STAFF MEMORANDUM

Meeting Date: **Wednesday, April 14, 2021**
DATE: April 9, 2021
TO: Urban Design Commission
FROM: Shubee Sikka, Urban Designer
SUBJECT: **Additional Review Information**

BLOCK ELEVATION WITH SIGNAGE SHOWN AS PROPOSED
 SCALE: 1/8"=1'-0"

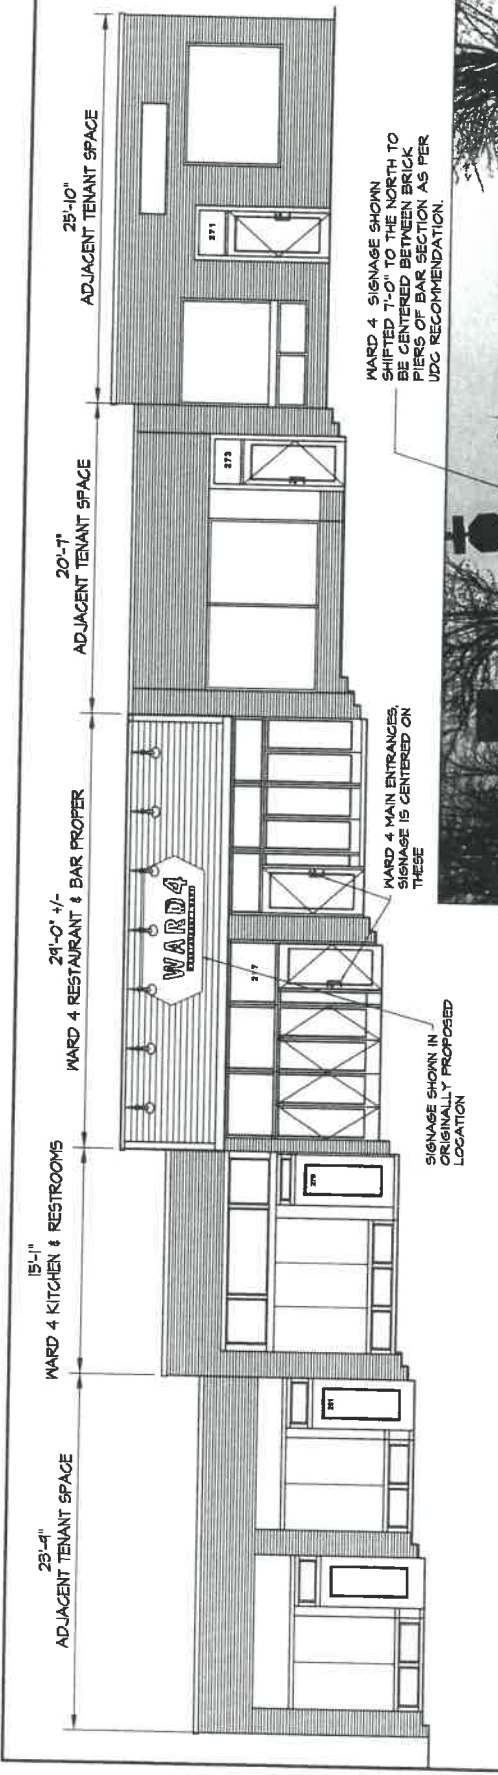
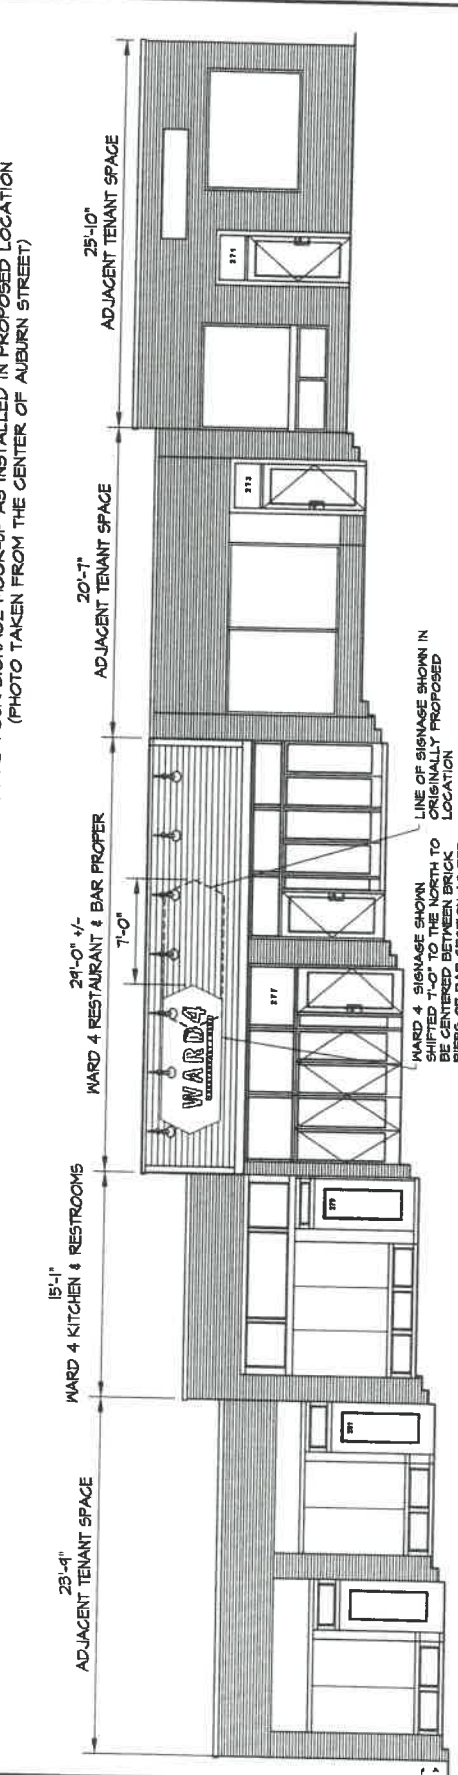
- Drawing showing the sign moved to the left and centered over the 16 feet business frontage and the trim painted. It will also be helpful to show the proposed sign on a photo of the existing façade.

- UDC also recommended to center the sign in height (which may not be possible because the lights are already installed).
- The additional materials are attached to this memo (attachment “A”).

- Staff noticed that the sign permit application said the façade frontage is 32 feet and the additional drawings provided by the applicant showed the façade frontage as 29 feet. Staff reached out to the applicant to provide the correct frontage for Ward 4. Applicant has provided an additional drawing with the correct frontage of 30 feet 3 inches (attachment “E”).

have enclosed a rendering of the front of the entire building with the sign off center on the façade as requested by the commission (see Exhibit "A" included herewith) prepared by Mark Lewis, the original designer of the façade and sign.
